Product Change Notification

Change Notification #: 105843 - 00
Change Title: IXB2800, IXB2800KAS, IXB28004XOC3, IXB28004XOC3FB, PCN 105843-00, FYI, Design change to prevent resetting of board when hot switching to a redundant power source
Date of Publication: January 24, 2006

Fig.1 Q11 location on C99378-00x baseboard

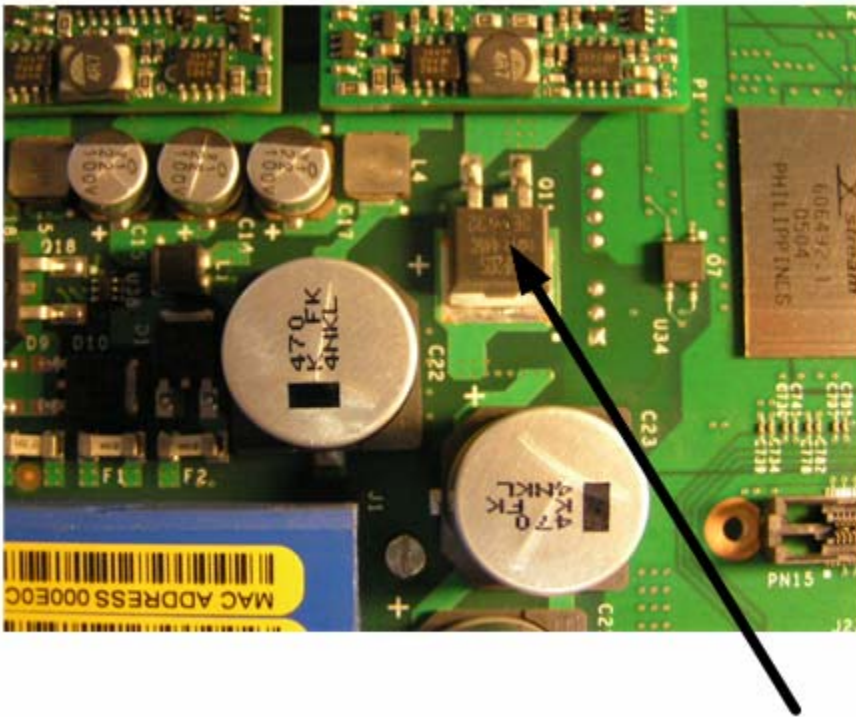
To prevent the sensing of a false over current condition and the subsequent resetting of the board when hot switching power sources a component change in the input protection circuit is required. The component to be changed is transistor Q11 located on the baseboard between the blue connector and main DC-DC converters –see Fig.1 below

Power MOSFET transistor Q11 is replaced with a transistor that has a much higher channel resistance. Q11 controls the initial charging of the input capacitors and will eliminate the false over current condition.
